REZONING LOT 10 SOUTH OF BLEAMS

THE PROPOSED PIT AT A UNIQUE LOCATION

THE MYSTERY OF DEEP REGIONAL WELLS K50,51

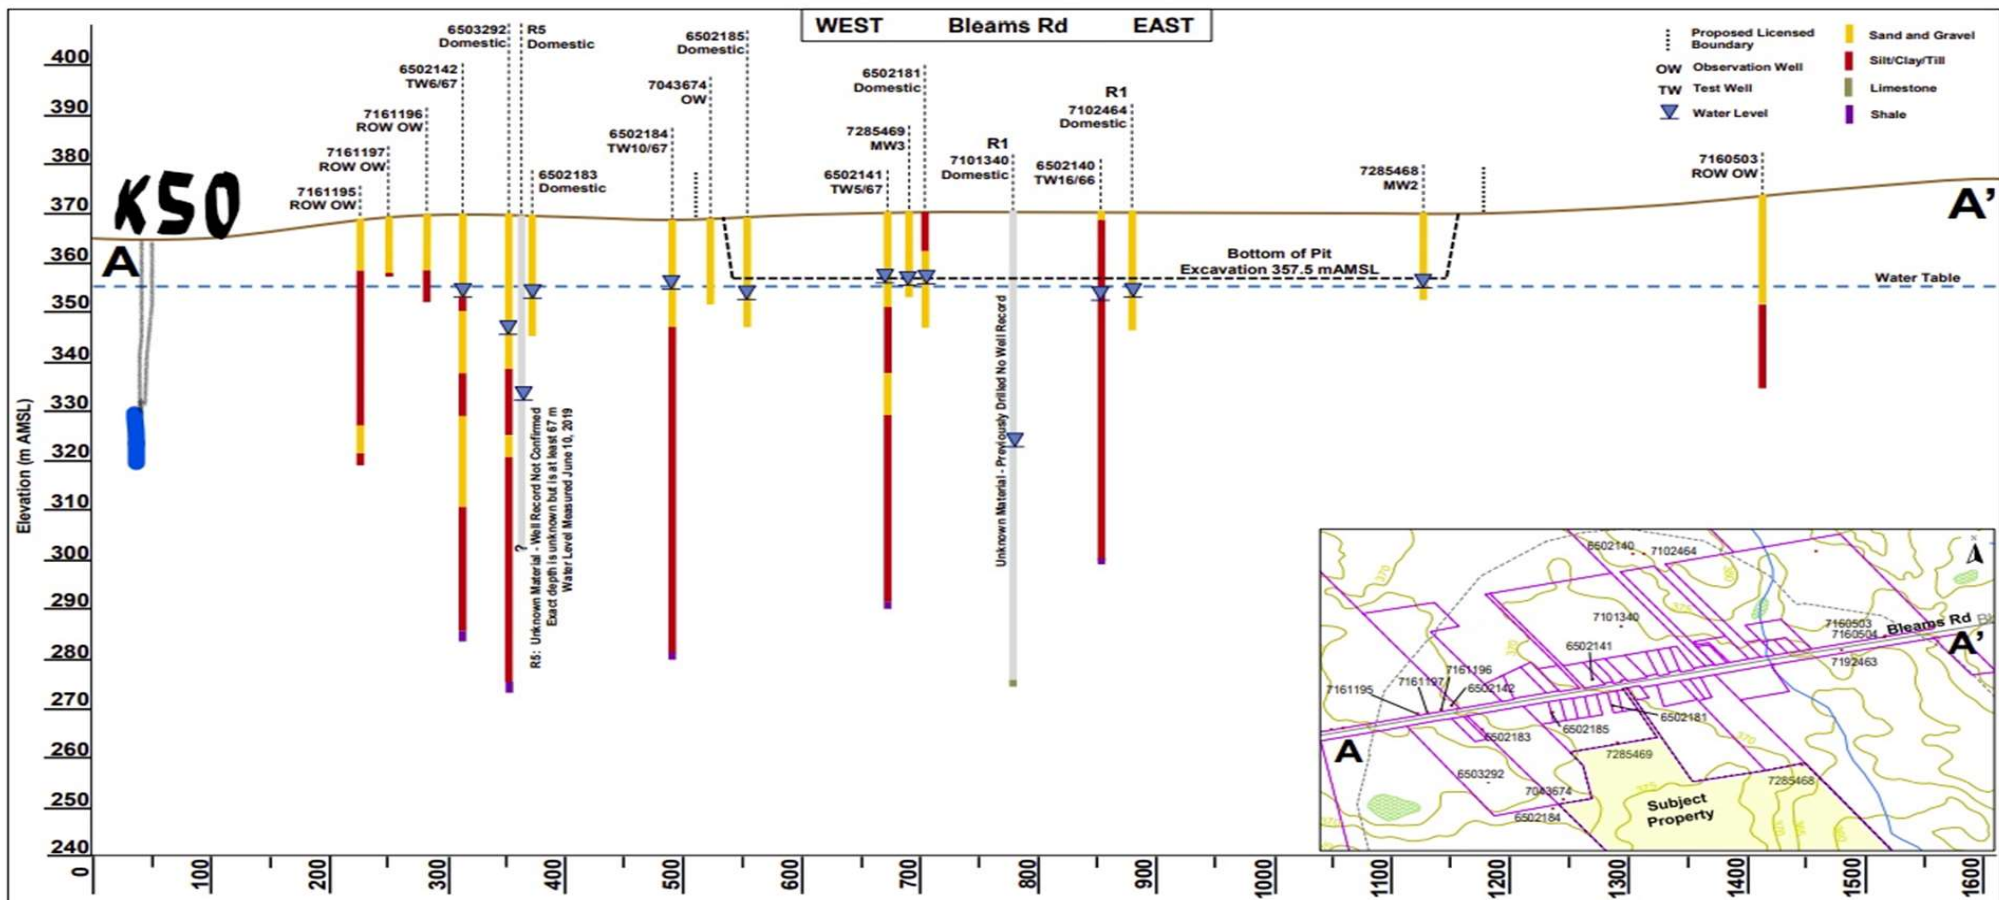
There would be as little as a 25 meter height difference between the pit bottom and the intake screens of the public wells.

Drill records of monitoring wells in the pit area between the Witzel pond and the regional wells show nothing but sand and gravel down to the 24 meter level (marked; MW6).

Therefore, it is highly likely this underground connection between the Witzel pond and the regional wells is why the public wells are so productive.

The fact that pump tests at the regional wells are reflected as far south as Witmer Rd 2 km from the wells, and northeast at Hallman lake (another Kettle pond) shown on top of the picture, support the underground connection.

GRAND RIVER SOURCE PROTECTION AREA MAP 8-103

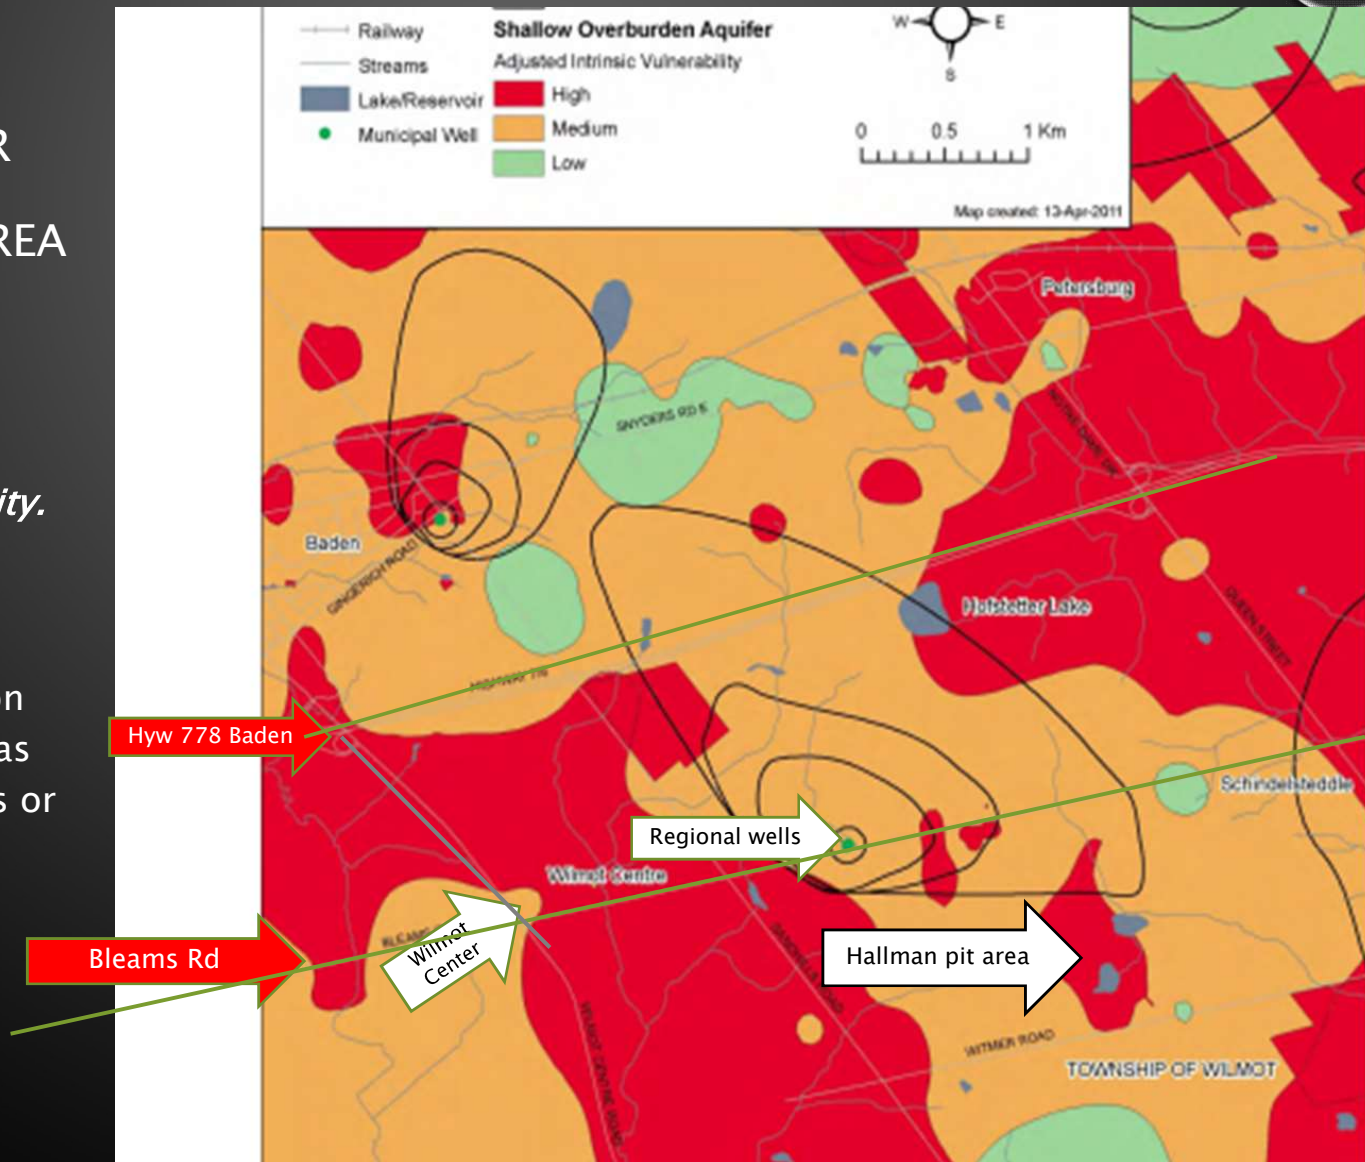
This current and up to date,
Grand River Source Protection
area map (page 228/535) was
not mentioned in the studies or
reviews for the Hallman pit.

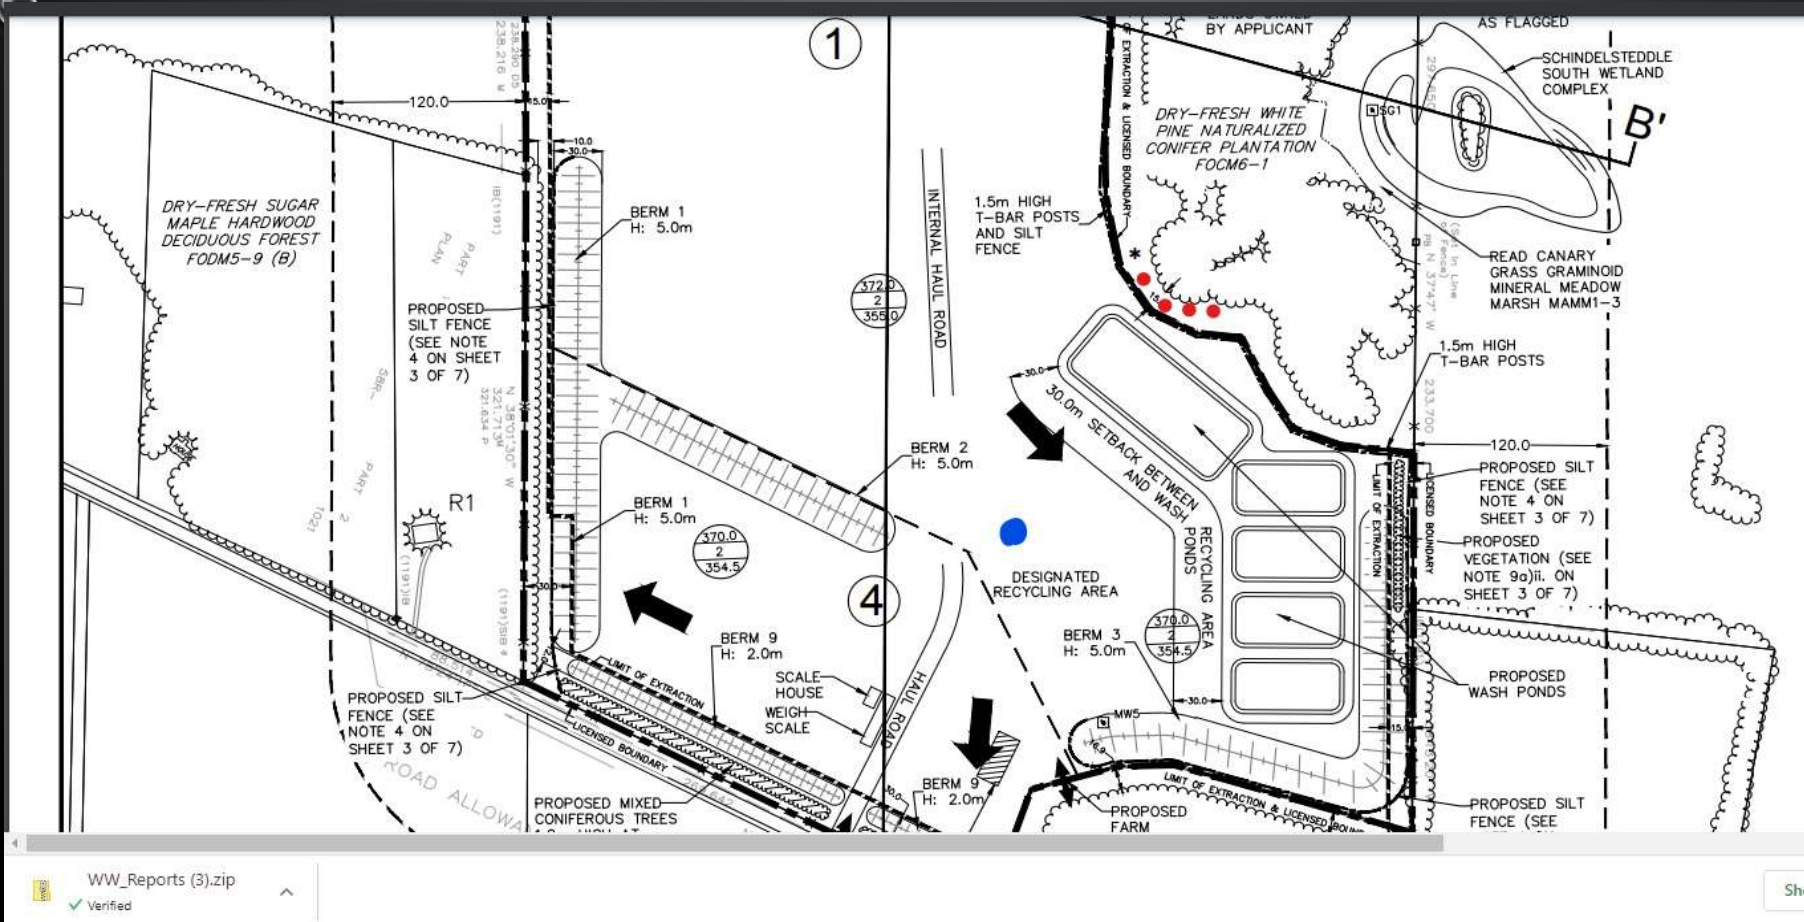
The operational plan with wash ponds to be built into the water table. The red dots shown are areas investigated during the environmental assessment. Blue dot Well # 6504418 is 3 times as deep as K50 and the well head is within the recycling area with no separation distance given. Since this area looks small for operating the gravel wash and recycling, and auxiliary uses are allowed in the woodlot by the pond, the zone 11 area, up to a 30 m distance to the Witzel pond, could be used for asphalt storage.

RUN OFF FROM ASPHALT STORAGE AS SEEN AT A PIT SOUTH OF AND BORDERING WITMER ROAD

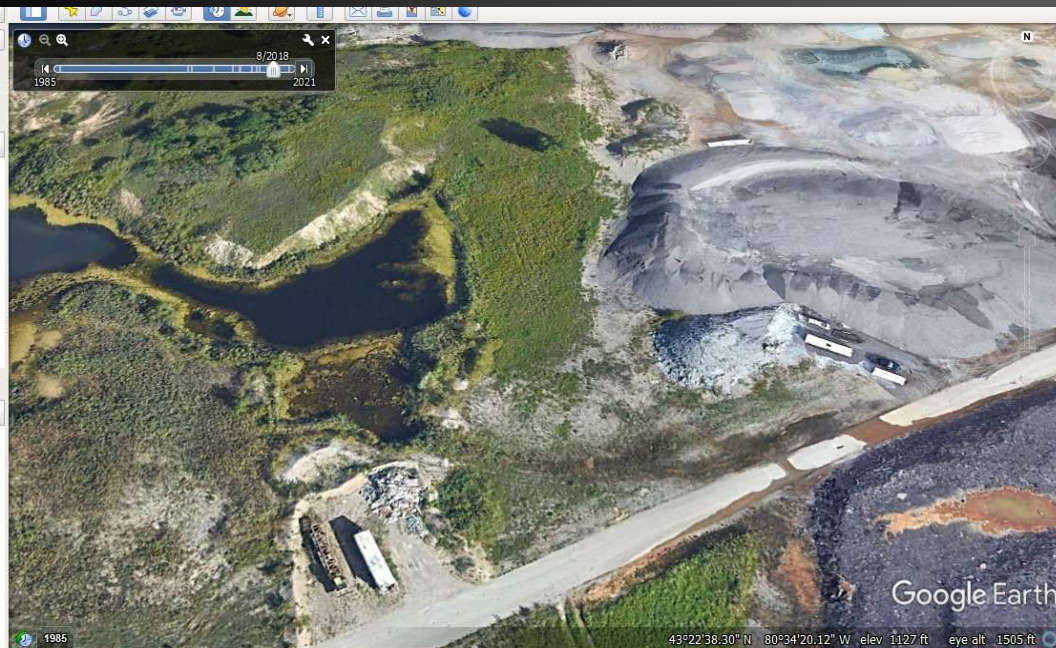
The brown patches in the picture are most likely hydro-carbon run off crossing the road even on a summer's day.

We are promised that a 30-meter distance between the asphalt recycling area and wash ponds sitting in the water table will keep us safe.

In reality, picture like these could be expected in the Hallman pit too.
